OHIO DEPARTMENT OF TRANSPORTATION Mike DeWine, Governor Jack Marchbanks, Ph.D., Director

Subject: Application for certification of Republic Wind Farm Project (Case No. 17-2295-EL-BGN)

Aeronautical Study No. 2018-WTE-11673-OE

## \*\* DETERMINATION OF NO HAZARD TO AIR NAVIGATION \*\*

Sectional Map for ASN 2018-WTE-11673-OE

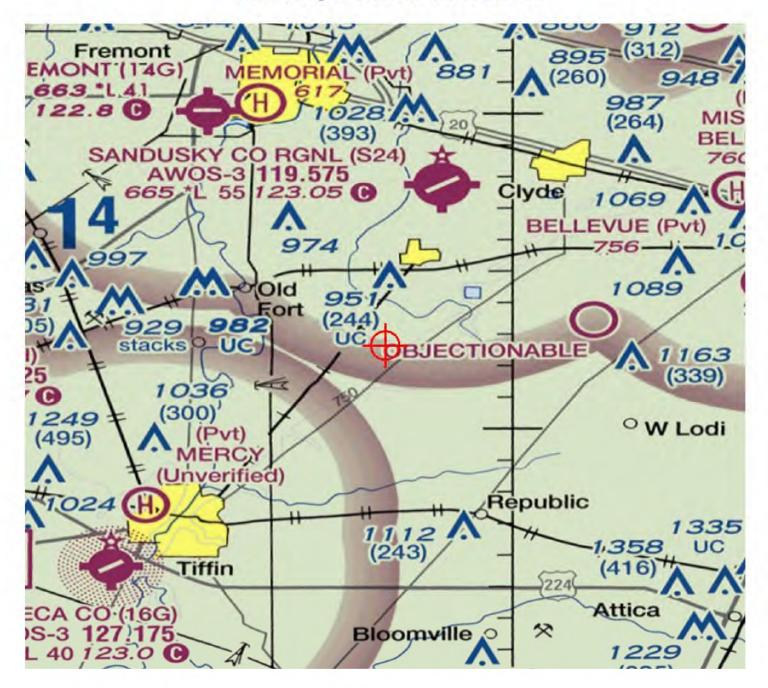
2018-WTE-11673-OE At 1336 AMSL Seneca County (16G) Tiffin OH, NDB RWY 24 increase S-24 MDA from 1460 to 1560 No Effect Height (NEH) 1289 AMSL. With the submission of a 2C accuracy survey (W/2C) 1460 to 1500 NEH 1299 AMSL. Increase CAT A/B/C/D circling MDA from 1460/1460/1460/1460 to 1560 NEH 1289 AMSL W/2C 1460/1460/1460/1460/1460 to 1500 NEH 1299 AMSL.

For the following studies as identified by their ASN, at least 10 days before the start of construction the proponent is required to file a FAA form 7460-2, Part 1, Actual Construction notification, at the OE/AAA website (http://oeaaa.faa.gov). This actual construction notification will be used to update published instrument flight procedures.
